ADDENDUM NO. 2

BELLE ISLE STATE PARK
NEW STORAGE BUILDING
11 PLEASURE DRIVE
DETROIT, MICHIGAN

FILE NO: 751/19193.SMD
WTA Project No. 2019131
DATE: November 3, 2026

SHEET NUMBER
TS

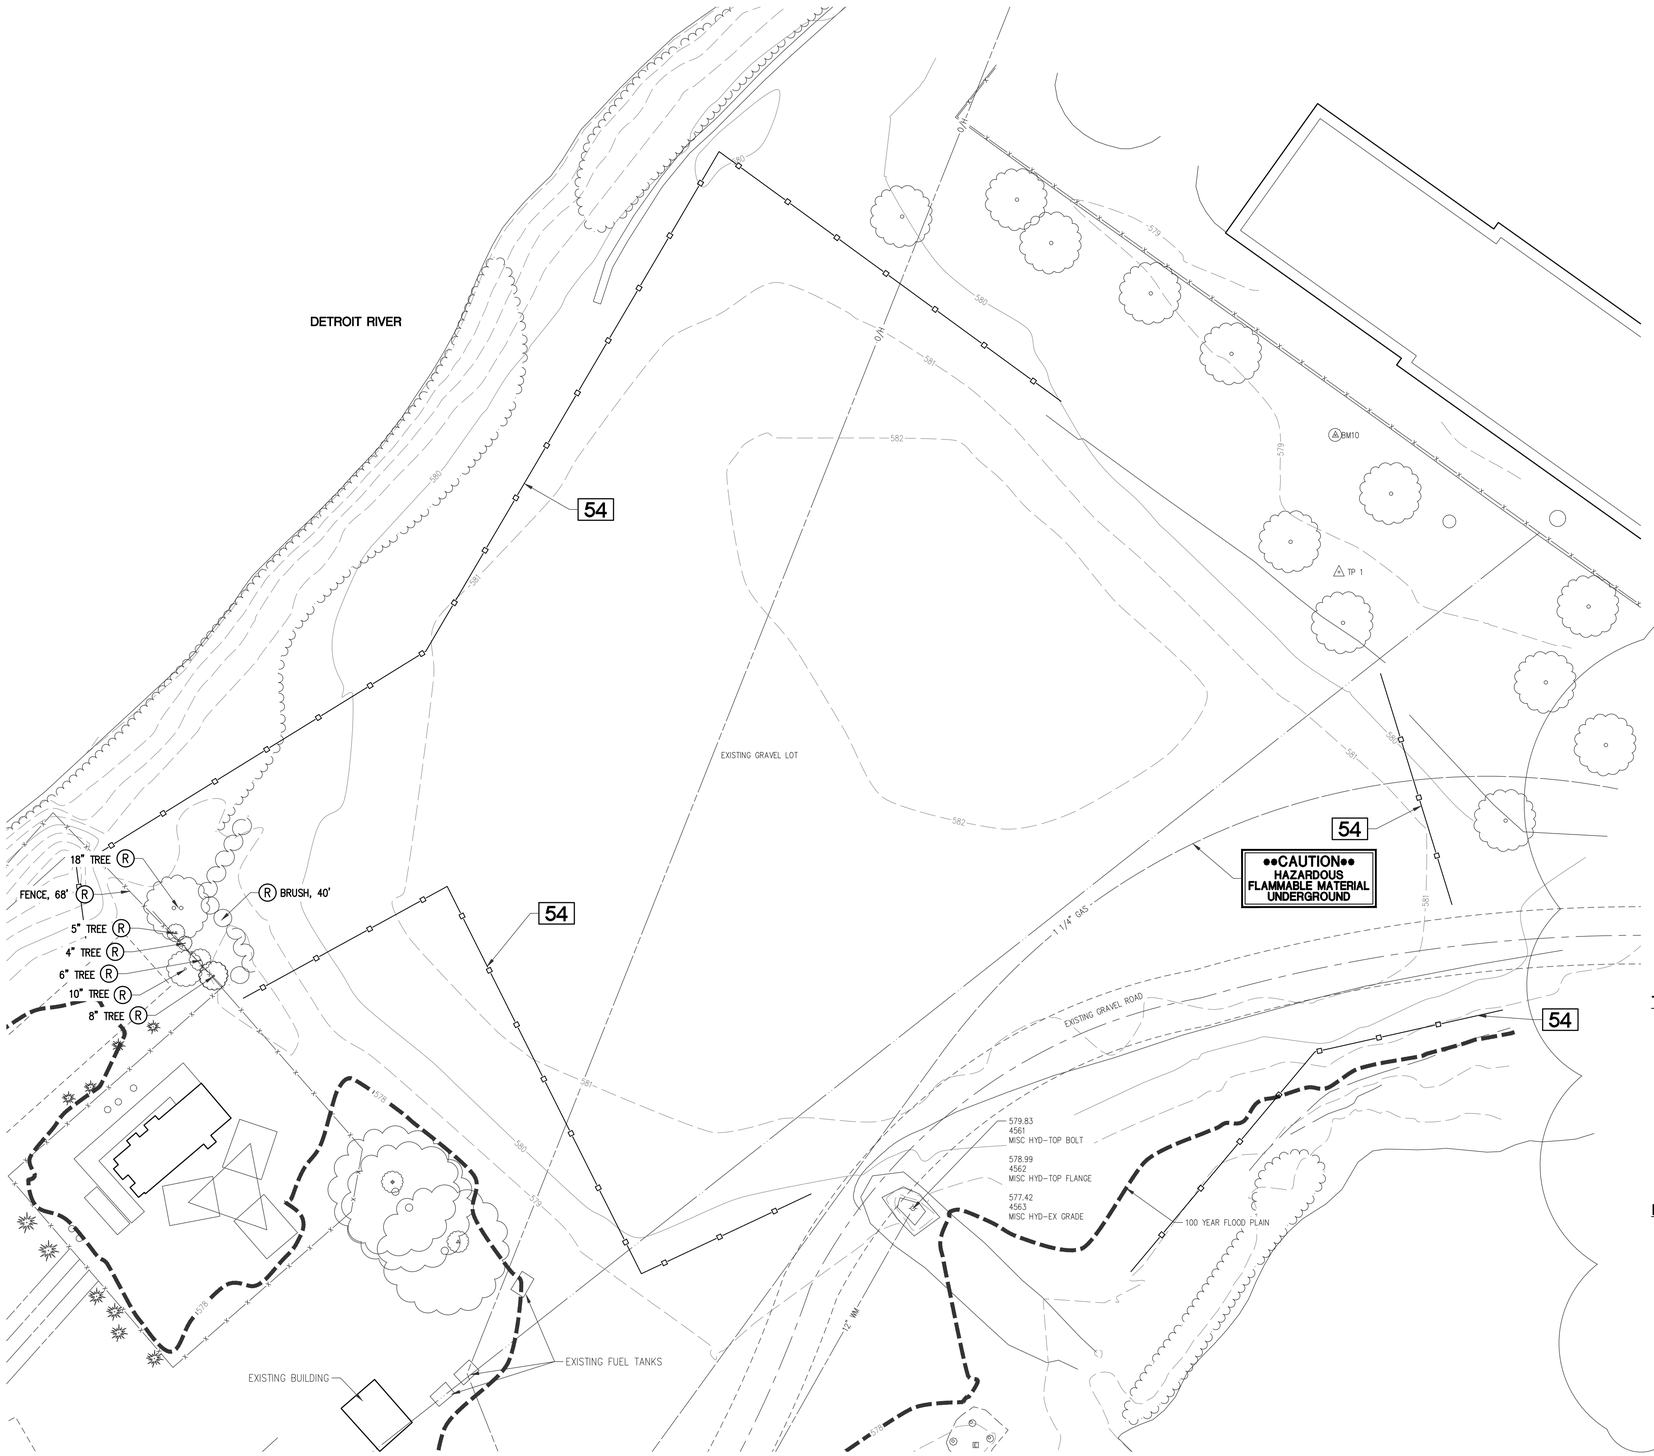
Item A1: Refer to Sheet TS (Attached)
- A. Added Unit Price for contaminated soil.

UNIT PRICE NO. 5: CONTAMINATED SOIL DISPOSAL
1. DESCRIPTION: PROVIDE COST FOR PROPER DISPOSAL OF SOIL CONTAMINATED WITH PETROLEUM OR OTHER HAZARDOUS SUBSTANCES.
2. UNIT MEASUREMENTS: CUBIC YARD

EXISTING CONDITIONS SHEET

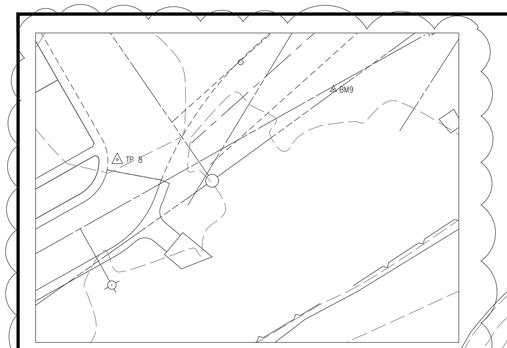
Item C1: Refer to Sheet C5 (Attached)
- A. TP/TM info was added plus second BM and TP points

8. Please provide the elevation and point description for BM 10 shown on drawings 5 of 8 and 7 of 8.

63. Does Sheet 5 of 8 of the civil plans ("Existing Conditions Sheet") reflect the existing grades that we can expect to find at the start of the work on this project?"

RESPONSE:
Yes.

SHEET NUMBER
A1.01

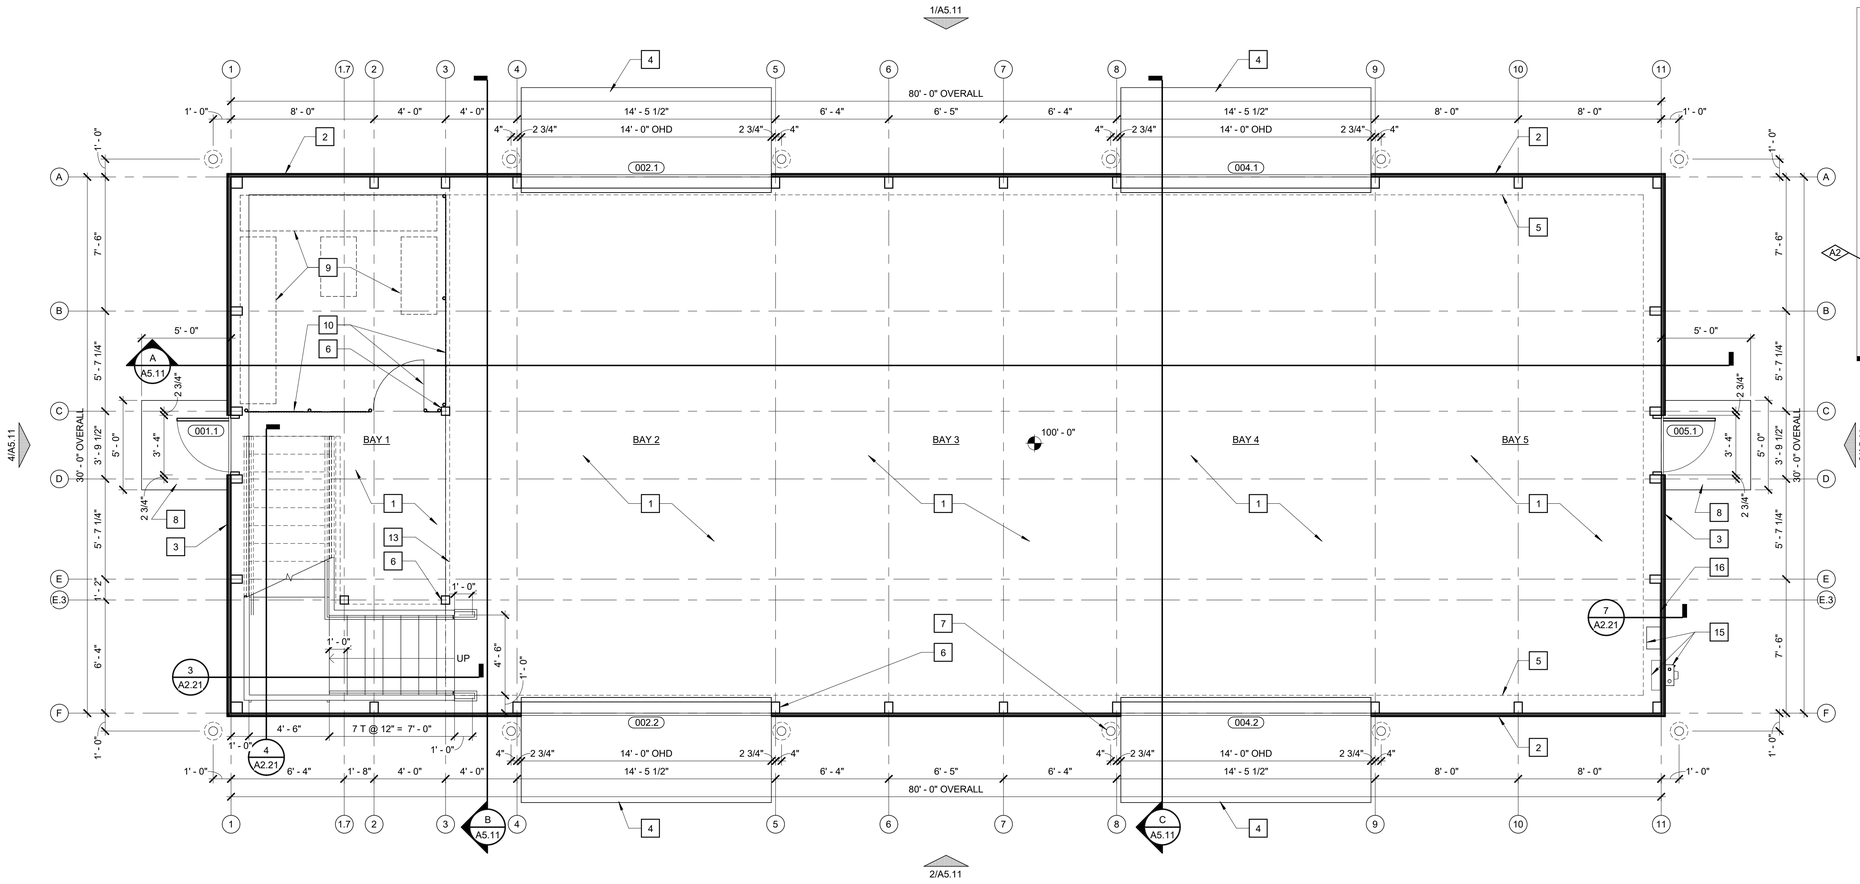
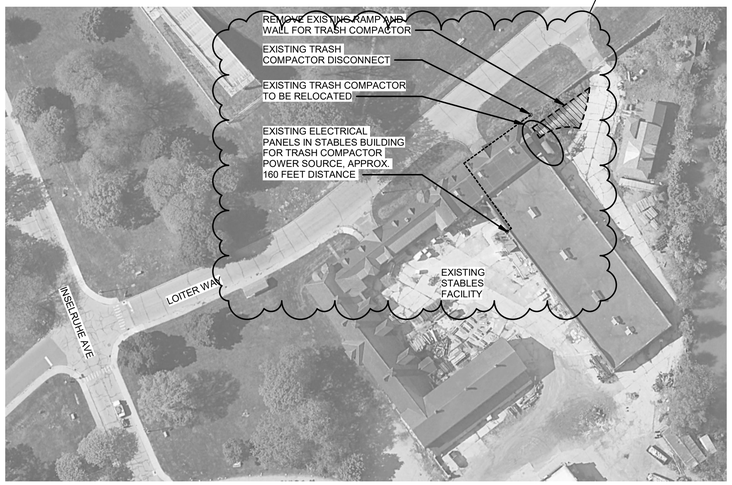
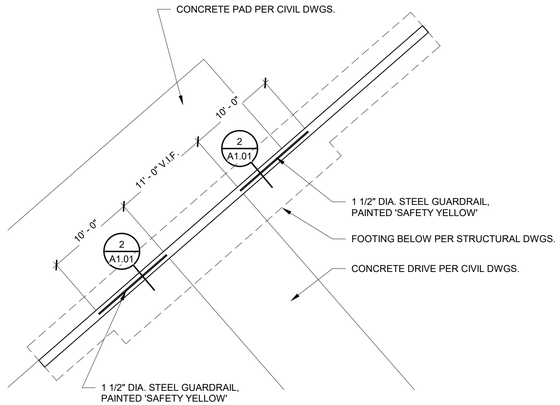
Item A2: Refer to Sheet A1.01 (Attached)
- A. Revised project work limits.
- B. Revised fuel dispensing system scope of work notes.
- C. Revised trash compactor scope of work notes.
- D. Added location for Trash Compactor power supply.

2. The contract documents indicate on drawing A1.01 and in the specifications, that the cost for the Trash Compactor Scope of Work is the responsibility of the successful contractor. This seems to include the unknown cost of the services of Reaction Distributing of Ajax, Ontario. We request that a designated allowance be established for the services of the Owner's delegated contractor Reaction Distributing to ensure that all contractors are provided the same cost quotation for the work of Reaction Distributing.

3. The contract documents indicate on drawing A1.01 and in the specifications that the cost for the Fuel Dispensing System be borne by the successful contractor. Please provide technical specifications for the required new double walled tank, the AST pumps, Clock Gage Alarms and other appurtenances for a complete fuel dispensing system. Additionally, clarify the scope of work regarding the dis-assembly of any pump or device connections to the existing fuel storage tanks to be relocated and a confirmation that the owner (MDNR) is responsible to remove 100% of the fuel in the existing tanks prior to being relocated.

Trash compactor relocation costs will be by Owner's separate contractor under designated allowance. Refer to Addendum 2.

EXISTING TRASH COMPACTOR WILL BE RELOCATED BY OWNER UNDER SEPARATE CONTRACT. CONTRACTOR SHALL COORDINATE WITH OWNER AND OWNER'S SEPARATE CONTRACTOR AS REQUIRED. REFER TO ALLOWANCE NO. 2.

SHEET NUMBER
A2.21

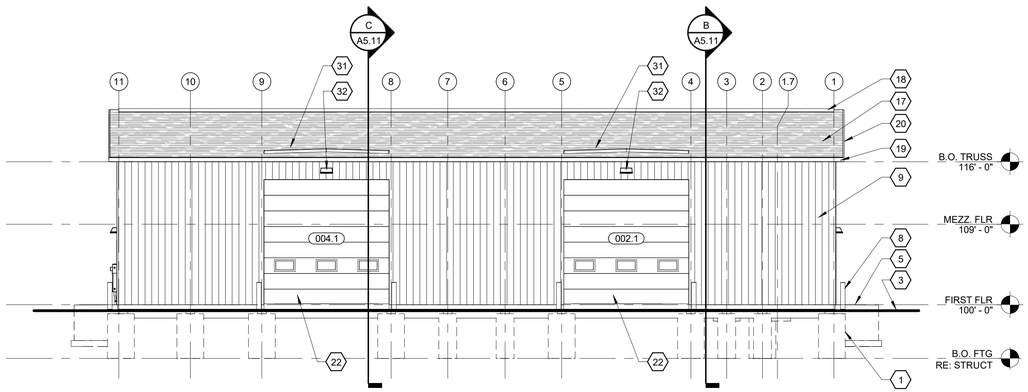
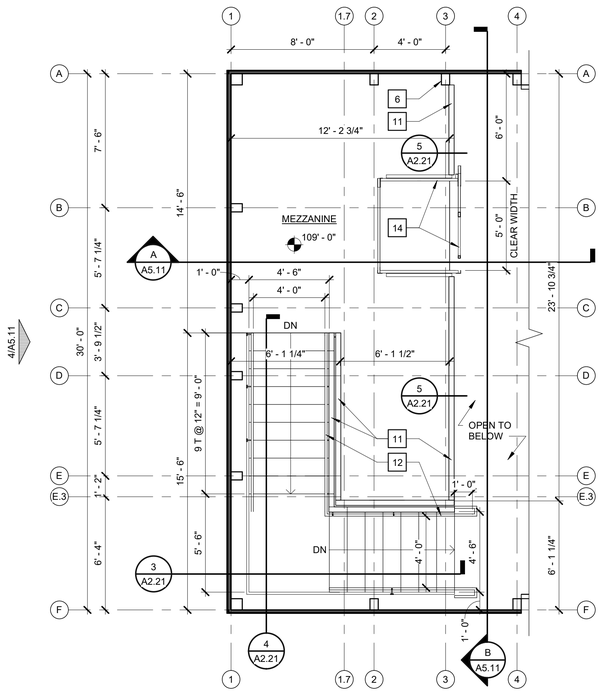
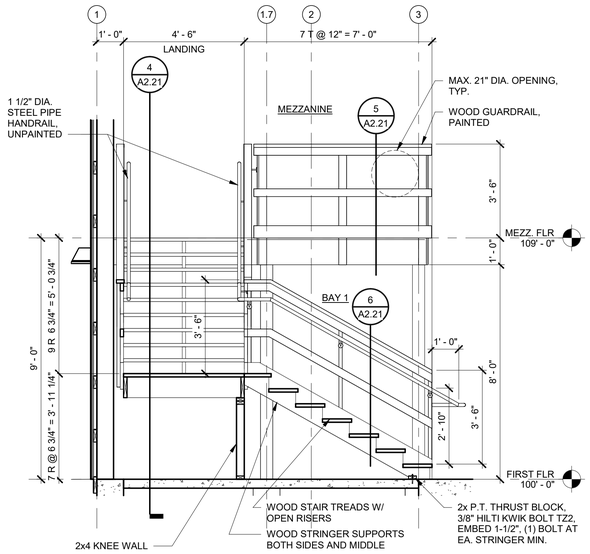
Item A3: Refer to Sheet A2.21 (Attached)
- A. Revised foundation design intent notes.

34. The Foundations Intent note on drawing A2.21 states 'Excavate all footings and foundations to a depth of 9'6" below grade'. Please clarify if this includes the interior foundation system as well as the frost slab foundations.

50. The Foundation Design Intent located on A2.21 (which would have been more helpful if located on sheet S2.01 or S3.01) states that the design is based on using conventional foundations with piers. Also states that all footings and foundations are to be excavated to a depth of 9' 6" below grade. The instructions go on to state that the contractor is to provide engineered fill per soils investigations to bottom of foundation bearing elevation. The bottom of the foundation bearing elevations are not clearly identified in the specs, the soils report nor on the drawings. If the design is to install engineered fill in the 9' 6" foundations to an unknown depth until 2000 psf (note 1 Foundation Notes dwg S3.01) is obtained, that should be clearly spelled out.

Bottom of foundation elevations are indicated on Drawings. Refer to Foundation Plan on Sheet S2.01 and Site Plan Sheet 7 of 8. The design intent describes the assumptions to be used for determining Base Bid amount.

SHEET NUMBER
A5.11

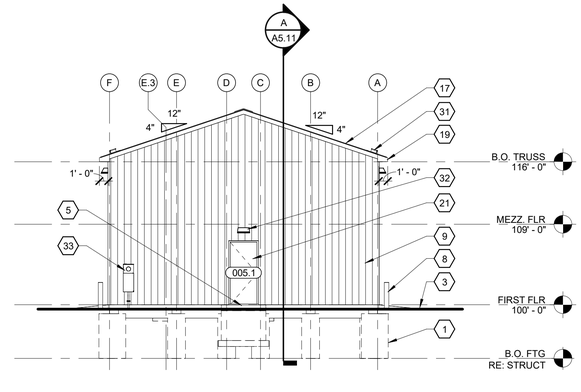
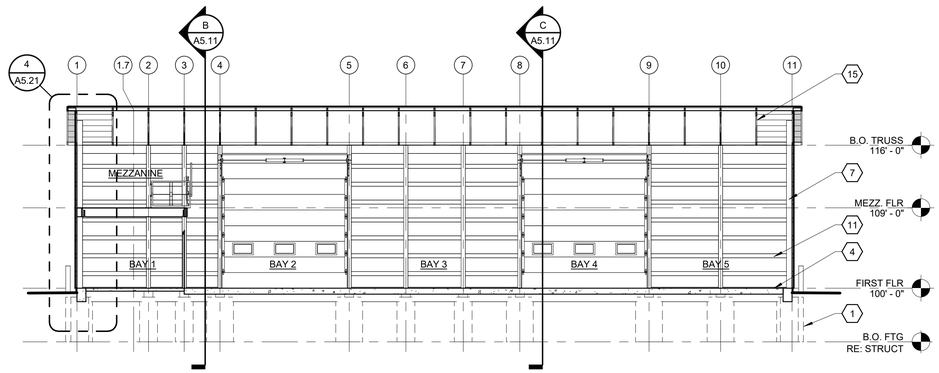
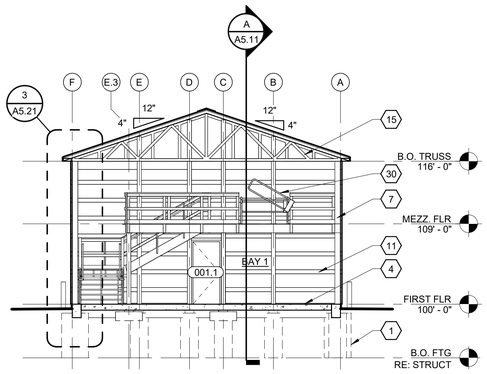
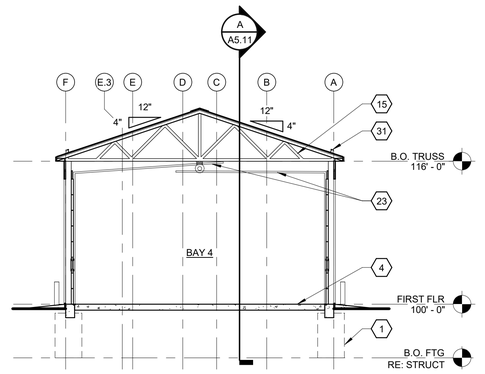
Item A4: Refer to Sheet A5.11 (Attached)
- A. Revised keynote 17.

57. Roof underlayment: Sheet A6.21 (keynote R1) and A5.11 (keynote 17) call for 15# felt. Specification 073113, 2.4.A calls for synthetic underlayment. Please confirm which one governs.

RESPONSE:
Specification shall govern.

SHEET NUMBER
A5.21

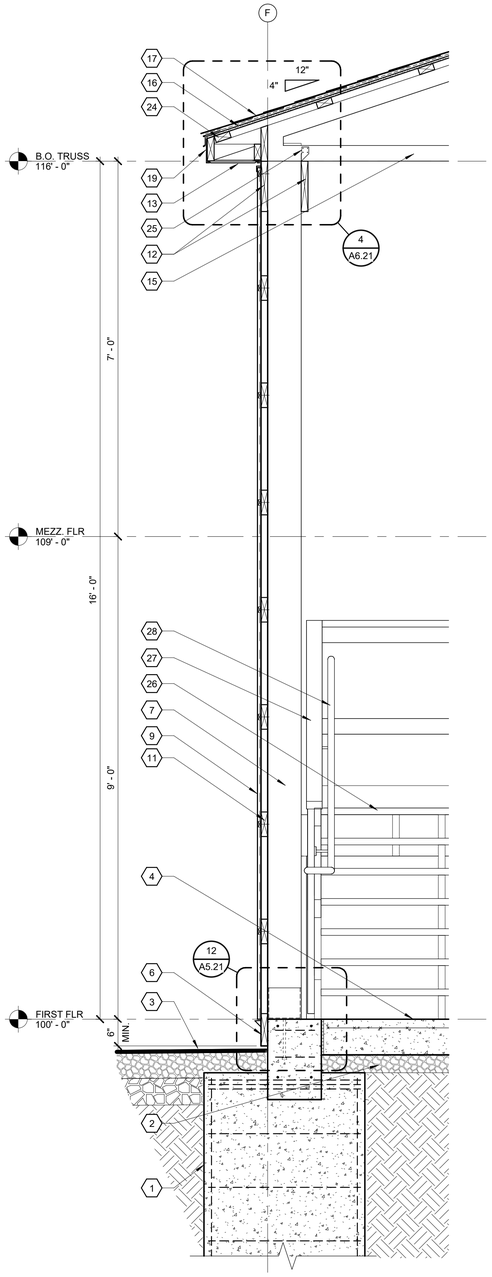
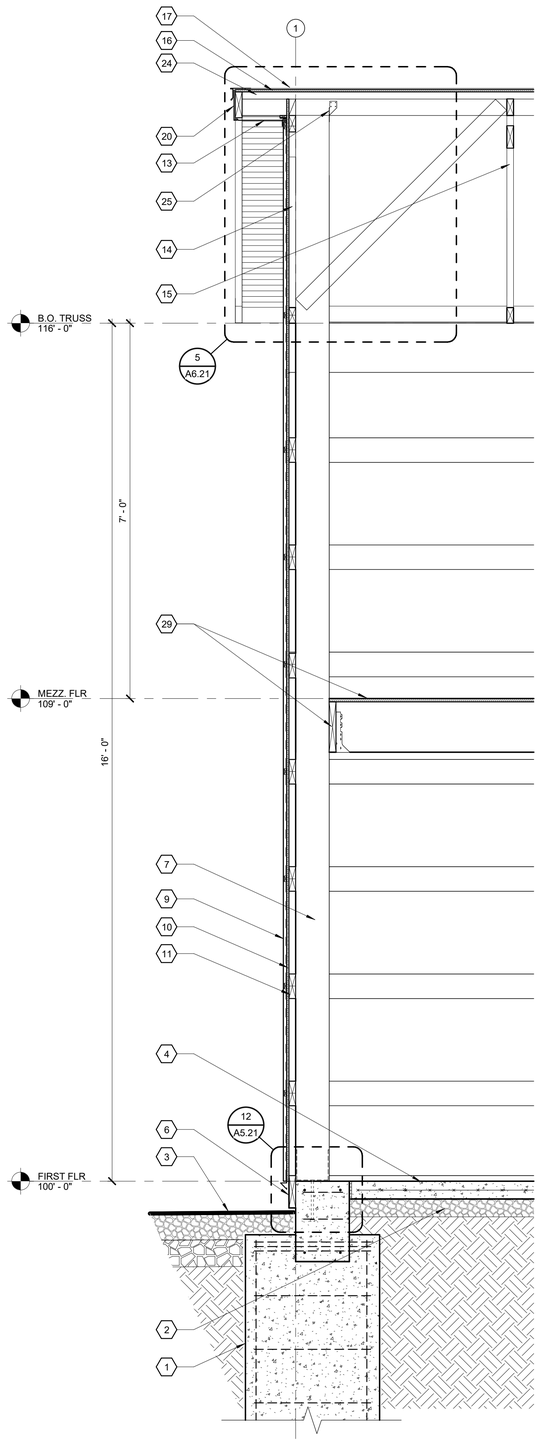
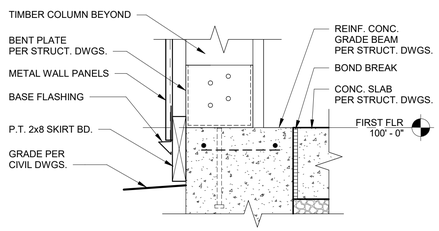
Item A5: Refer to Sheet A5.21 (Attached)
- A. Revised keynote 17.

6. Please provide more information on the Rain Guard Diverter System designated at item 31 in the Materials Keynote on drawing A5.21 on the New Storage Building Project for the MDNR on Belle Isle. It would be helpful to understand the design specifics: length, cross-section, gauge, preferred location and fastening mechanism for these 4 items.

Refer to Addendum 2 for revised spec Section 073113 - Asphalt Shingles.
